ECN for USB Power Delivery Specification Revision 3.2

Version 1.1, 2024-10

Title: ECR HardReset Processing Time Clarification

Illustration of the clarification:

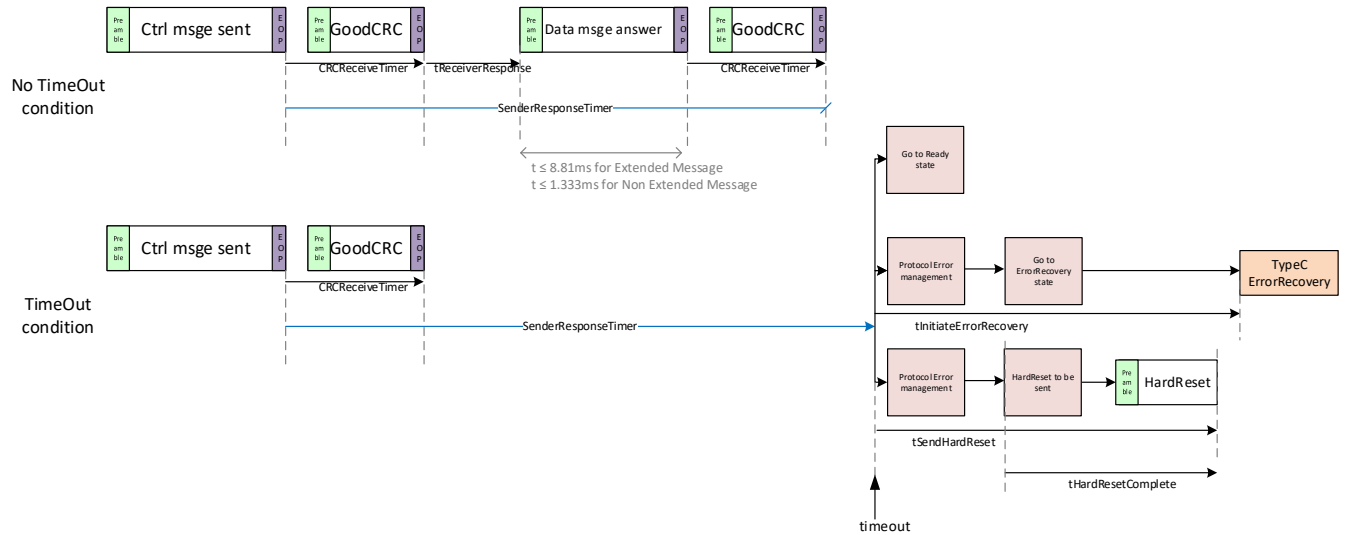
When SenderResponseTimer expires, PE sends the information to PRL which asks PHY layer to send HardReset message, or to go to ErrorRecovery State or PE goes back to Ready State
Depending on implementation, it might take time to process the timer expiration and determine next step and send the message or to direct to ErrorRecovery or HardReset: currently the PE state diagram is silent on this which leads to false fail in compliance.

- Extend tSenderResponse max to 50ms from 33ms. The current time allows very little room beyond a 10% timer error to process.
- Allow PD2 to use the same max time.
- Add a time for processing and sending the hardreset (matches protocol error hard reset timing)
- Also provide a time for going to ErrorRecovery on a timer error.

What for ?	Min (ms)	Max (ms)
CRCReceiveTimer (tReceive)	Timeout	0.9	1.1
SenderResponseTimer(tSenderResponse)	Timeout	27	50
VDMResponseTimer (tVDMSenderResponse)	Timeout	24	50
tReceiverResponse	Max time to send response	-	15
tHardResetComplete	Max time to send message	4	5
tSendHardReset	Max time to send message		15
tInitiateErrorRecovery	Max time to ErrorRecovery		15
